Oakdale West Estate Modification 5

State Significant Development Modification Assessment
(SSD 7348 MOD 5)

November 2020

Figure 4 | Proposed Concept Proposal

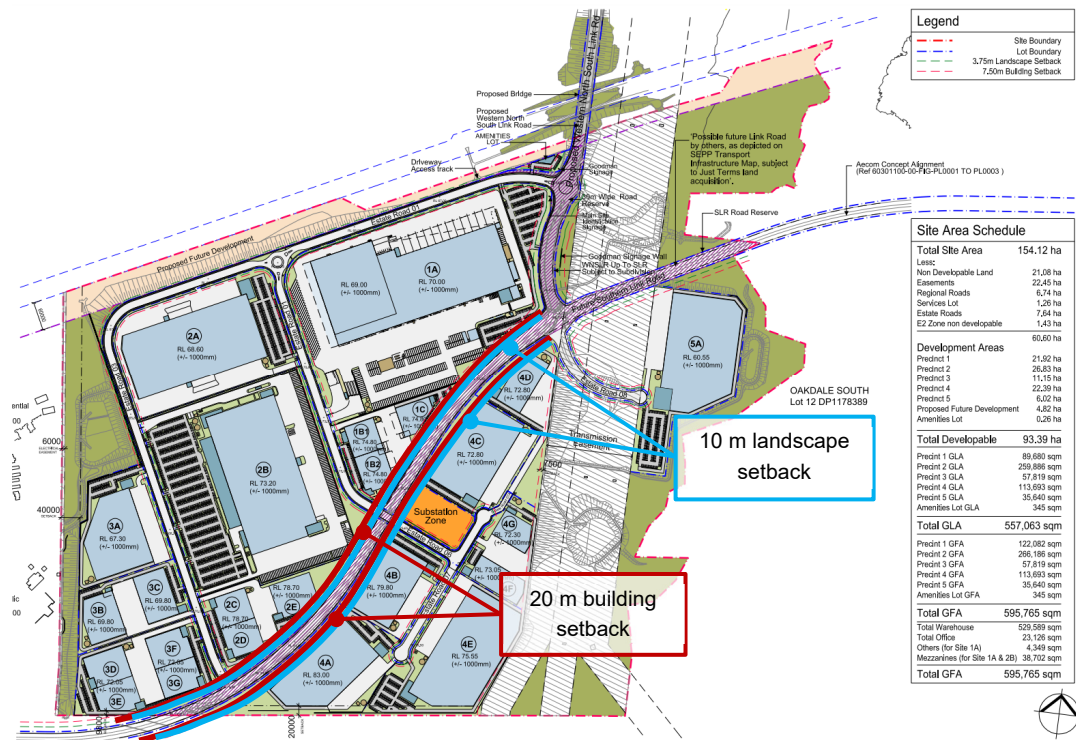
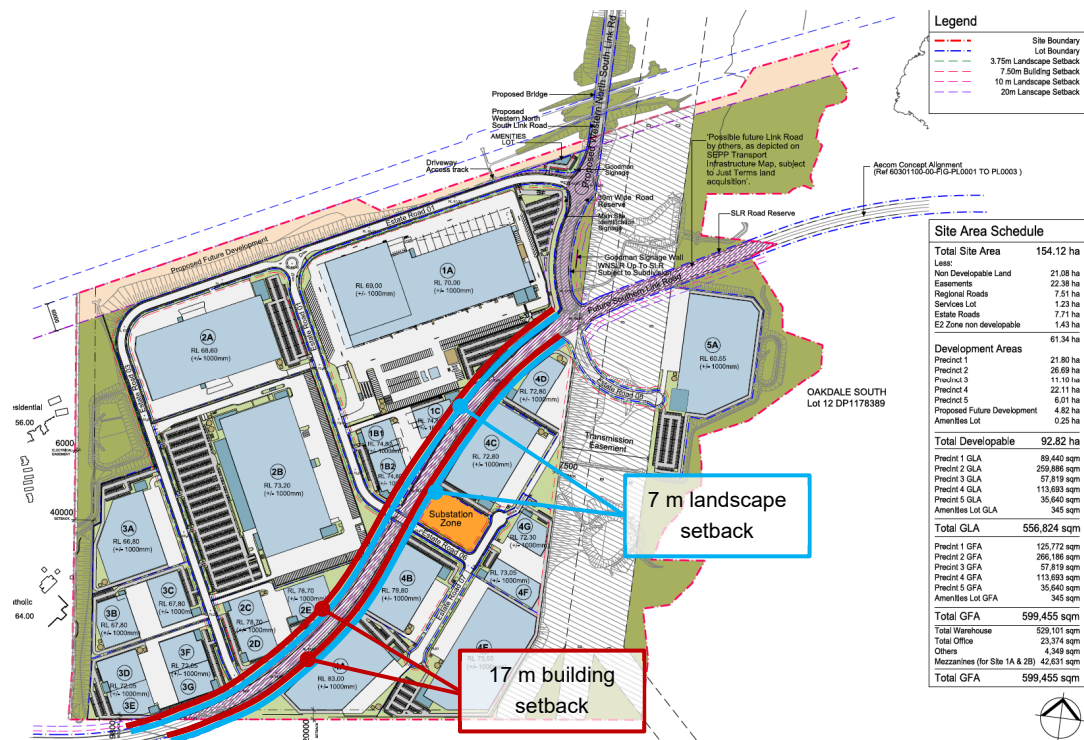
To satisfy the requirements of TfNSW, the Applicant proposes to decrease the building and landscaping setbacks to the SLR road reserve from 20 m and 10 m to 17 m and 7 m in the Concept Plan for all lots. This would result in an additional 3 m on both sides of the SLR road reserve. The modification also includes revised landscaping for the Stage 1 development that aligns with the reduced setbacks. The proposed Stage 1 landscaping includes trees with mature heights ranging from 6 m to 30 m, shrubs along the SLR frontage, and planting within the site and along the perimeters.

Council raised concerns with the potential visual impact of retaining walls along the SLR on the streetscape and suggested the Applicant reconfigure Precinct 1 and amalgamate several buildings to retain a 10 m wide landscape setback. In its submission, TfNSW indicated it was satisfied with the proposed 36.6 m wide SLR road reserve and proposed landscape and building setbacks, provided no future buildings, structures or utilities would be built within an area outside of the widened SLR road reserve that was identified on a plan attached to the submission. Development consent has not been granted under SSD 7348 for any building, structures or utilities within the area outside the widened SLR reserve identified by TfNSW nor are any proposed under this modification application.

The Department has identified the EA provides inconsistent information about the reduced setbacks to the SLR road reserve, nominating building setbacks of both 17 m and 17.15 m and landscape setbacks

of both 7 m and 7.15 m. The Department considers reducing the building setback to 17.15 m and landscape setback to 7.15 m could sufficiently accommodate the widened SLR required by TfNSW, being an additional 2.85 m on both sides of the SLR road reserve.

The Department has recommended revising Condition B10, Schedule B of the SSD 7348 development consent to require the Applicant to provide 17.15 m building setback from the SLR road reserve across the OWE. This would include a 7.15 m landscape setback. It is also recommended to update Figure 4 in Appendix 2 of the SSD 7348 development consent to show the landscaping plans included in the MOD 5 EA.

Figure 7 | Proposed Precinct 1A Layout

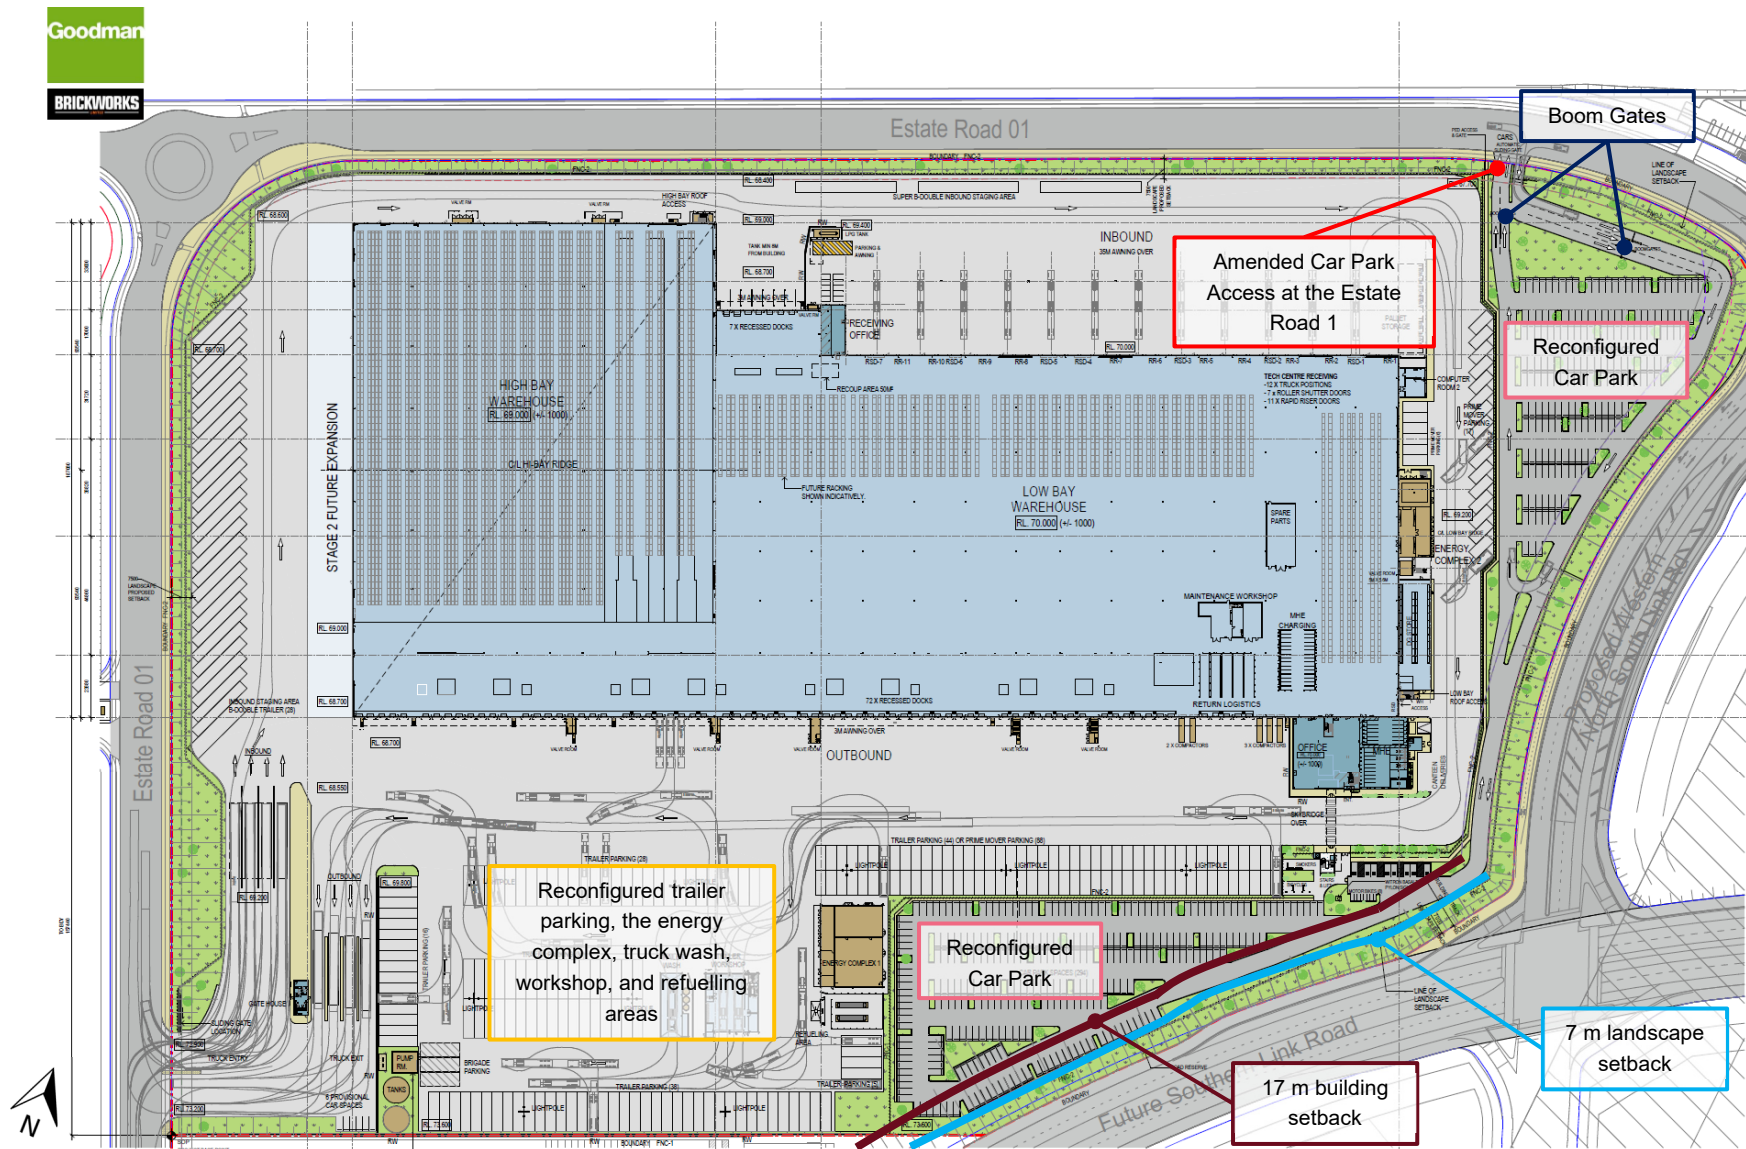
The Applicant claimed the amended car park layout is required to meet the secured tenant's operational requirements and to address the potential for queuing on Estate Road 1. By reconfiguring the car park internal road layout and installing boom gates, the modification would not result in substantial queueing of vehicles entering the parking lots and queuing on Estate Road 1.

Issues	Recommended Conditions
<p>contained within the site on three inbound lanes to minimise queuing impacts on Estate Road 1.</p> <ul style="list-style-type: none"> • The Department considers the modification would provide sufficient parking spaces for warehouse building 1A as it would increase the parking spaces from 472 spaces approved under SSD 7348 MOD 2 to 473 spaces. • The Department's assessment concludes the amended Precinct 1 car park layout has balanced the requirements for providing a wider SLR reserve, providing a 7 m wide landscaping area, improving the site's internal manoeuvrability and ensuring the Building 1A tenant's operational efficiency. • The Department has recommended updating Condition D69, Schedule D of the SSD 7348 development consent to require the Applicant to ensure parking for Stage 1 is provided in accordance with the MOD 5 EA and to construct the Building 1A car park as proposed in the MOD 5 EA.

Figure 8 | Approved and Proposed Biodiversity Offset Sites

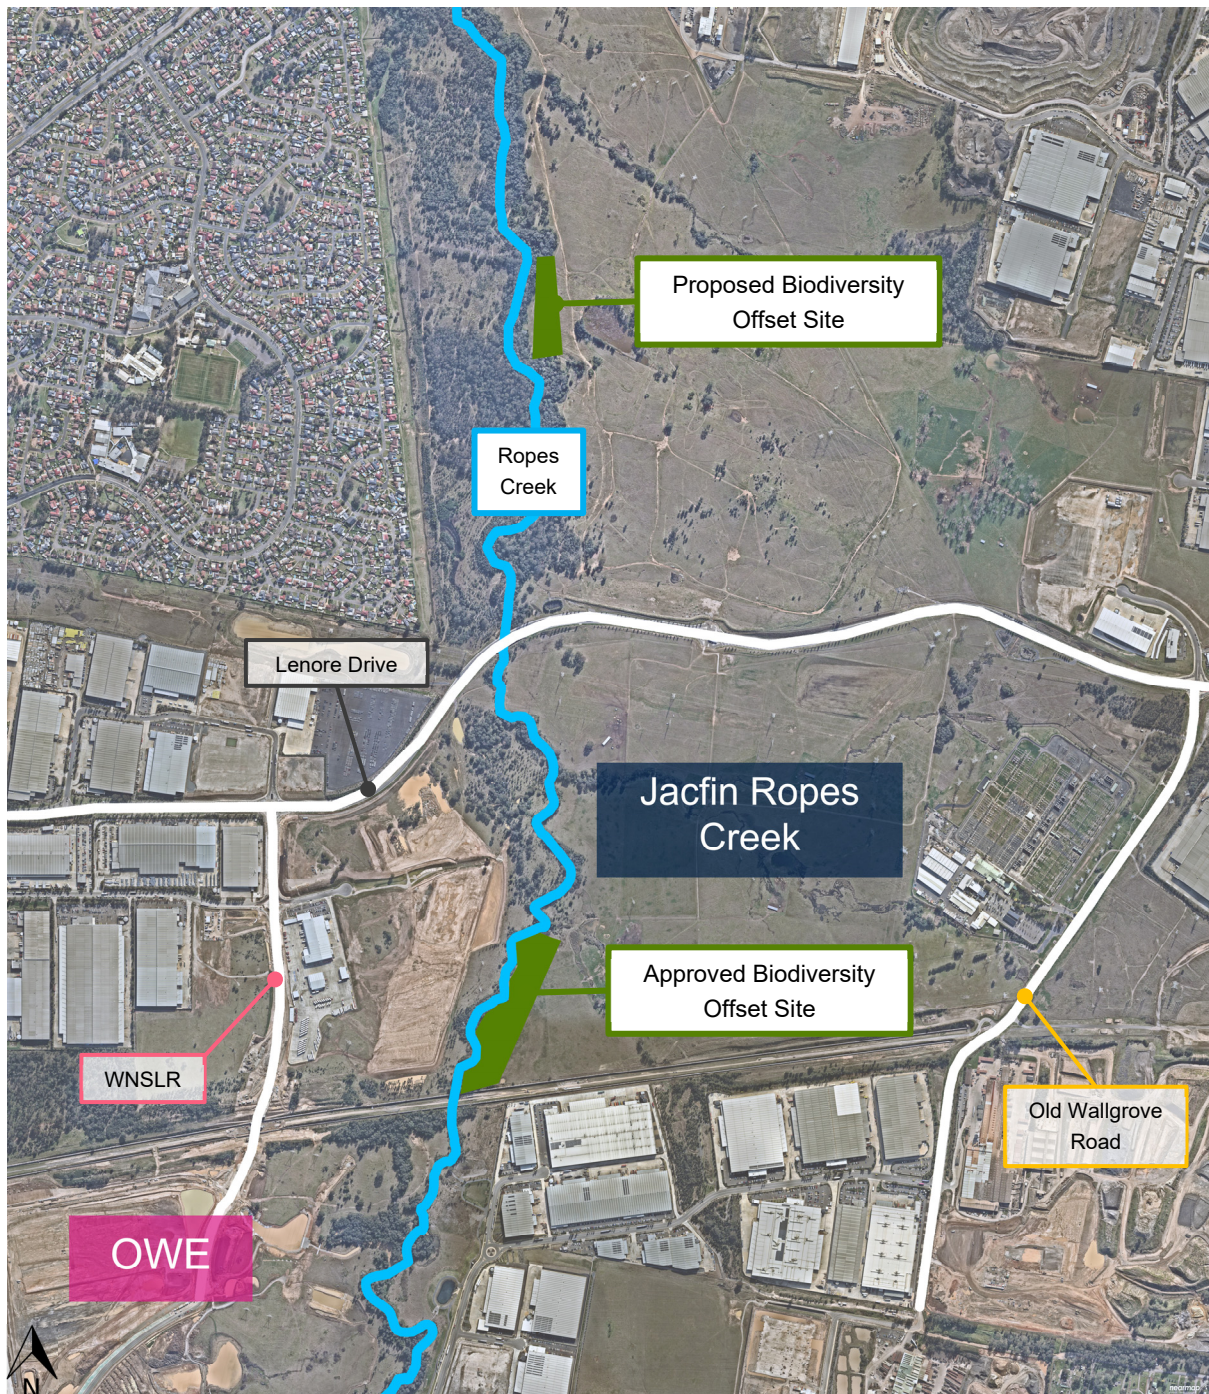
Due to difficulties in gaining access to the approved biodiversity offset site, the Applicant has identified an alternative site approximately 1.8 km to the north. The offset requirements, as approved, would still be achieved and the amended location would result in substantially the same ecological outcome.

- The EES Group has reviewed the modification and provided no specific comments on this issue.
- The Department notes the EES Group did not have comments on the use of the alternative biodiversity offset site and further notes the modification would only change the location of biodiversity offset site and would not amend the approved native vegetation removal and biodiversity offset credits.

- The Department has recommended revising Condition D93 to align with the change of biodiversity offset site and retaining Condition D94.

Figure 9 | Designated Dangerous Goods Storage Areas

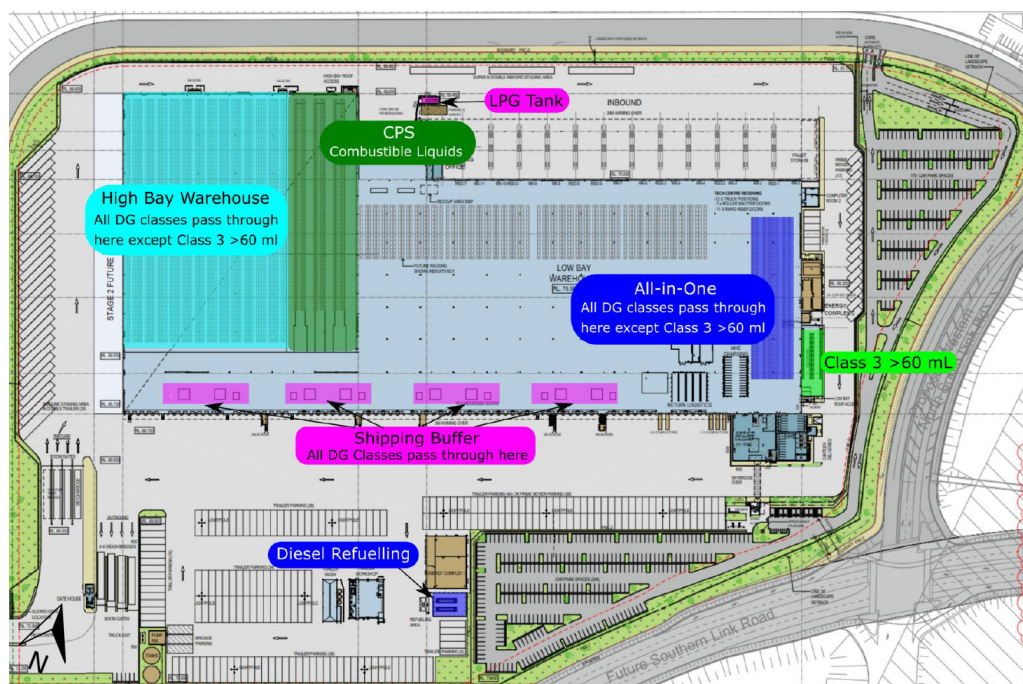
FRNSW reviewed the FHA and recommended that if the Building 1A would incorporate a fire engineered solution (FES), the Applicant should engage with FRNSW in the fire engineering brief (FEB) consultation process at the preliminary FES design phase, the FES should address clauses E1.10 and E2.3 of the National Construction Code (NCC), particularly for firefighter intervention and accessibility. FRNSW made comments on in-rack sprinklers and the provision of cages/mesh protection for the aerosols stored within the racking system of the high bay warehouse area.

The Department's Hazards Specialist has reviewed the FHA and identified one of the critical hazards is the potential for spillage of Class 8 DGs. The Department acknowledged this would be managed on site as the development includes sufficient safeguards to capture any spillage, including spill kits in the DG storage area and spill containment within the site boundary to prevent spillage running off-site. The FHA updated the full warehouse fire scenarios with the increase of total DG quantities stored within the Building 1A. As Building 1A and surrounding developments are located within the industrial zoned WSEA, the FHA adopted the individual fatality risk criteria for industrial development in its full warehouse fire scenario assessment. The FHA demonstrated with the increased DG quantities in place, operation of the Building 1A would remain in compliance with the relevant criteria.

The Applicant responded to FRNSW comments that the FEB consultation had commenced and a Fire Safety Study (FSS) incorporating the FES was provided to FRNSW. The submitted FES addressed Clauses E1.10 and E2.3 of the NCC required by FRNSW. Firefighter intervention and accessibility has been addressed via the introduction of the fire tunnel and a walkway above the Receiving Canopy. In-rack sprinklers and caged areas for aerosols would be included in the fire safety system design described in the FSS prepared in consultation with FRNSW prior to commencement of construction of Building 1A. The Department provided the Applicant's response to FRNSW who did not provide further comments. Council has also reviewed the modification, the FHA and recommended revising conditions of consent in accordance with the amended quantities of DGs stored within Building 1A.

The Department has recommended amending conditions of consent to ensure the recommendations of the FHA are implemented and monitored and to reflect the increase in quantity of Class 8 DG. The Department's assessment concludes the modification would meet the tenant's operational requirements while remaining in compliance with the individual fatality risk criteria for industrial development.

Figure 10 | Proposed Landscaping along the SLR in Precinct 1

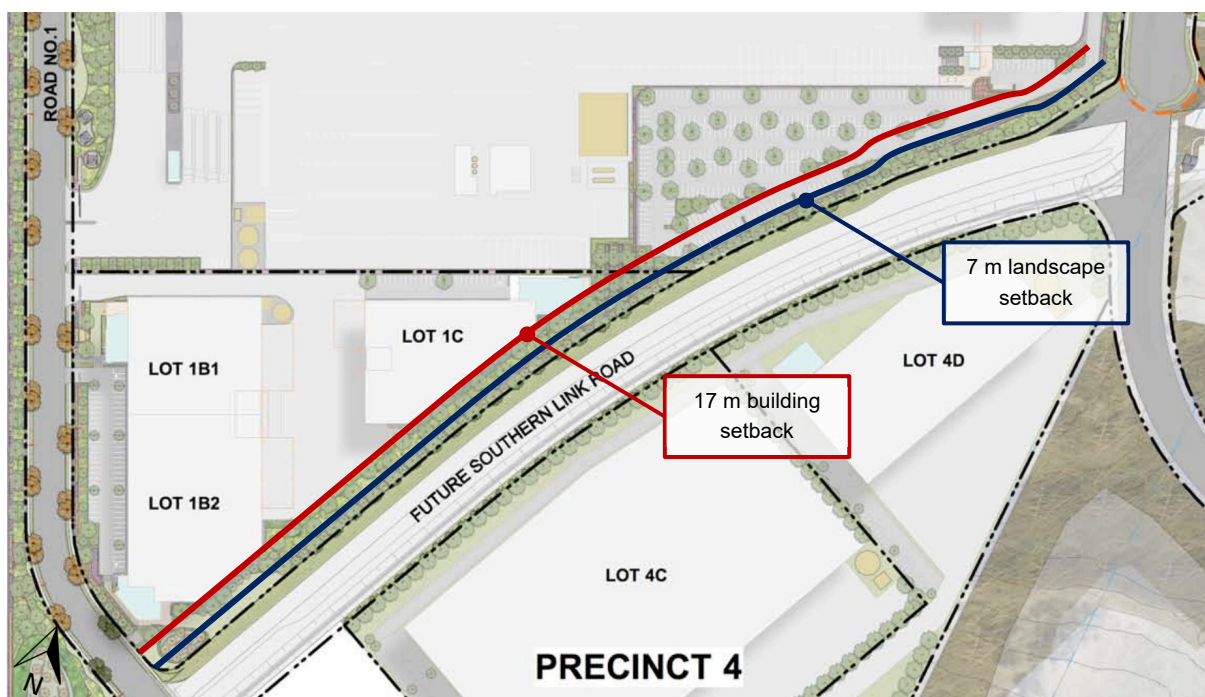
The Department notes while landscaping along the Precinct 1A car park fronting the SLR reserve would be reduced to a minimum of 7.15 m wide, the Applicant would provide landscaping areas greater than 7.15 m wide along the SLR frontage in other parts of the Precinct 1A. Furthermore, in Precincts 1B and 1C, the Applicant has proposed landscaping within the entire 17.15 m wide building setback area along the SLR road reserve, thereby exceeding the approved 10 m landscaping requirement by 7.15 m (see **Figure 10**). The Department considers the decrease in landscaped area is a necessity to facilitate the future SLR without compromising the Applicant's approved developable land. As a significant portion of the landscaping provided within the Precinct 1 would exceed 7.15 m, the Department considers the proposed landscaping would be sufficient to screen and soften the built form when viewed from the future SLR.

The Department acknowledges Council's request for a 10 m wide landscaped area along the future SLR across the OWE as originally approved under SSD 7348. On balance, the Department considers the Applicant has maximised landscaped areas where possible, while satisfying the updated requirements of TfNSW for additional lands for the future SLR without compromising the developable area approved under the Concept Plan or the Stage 1 development. The Department notes, during the preparation of future DAs for Precincts 2C-2E, 3 and 4, the Applicant would consult with Council regarding detailed design and potentially reconfigure the Concept Plan approved layout and achieve the originally approved 20 m and 10 m building and landscaping setbacks along the future SLR.
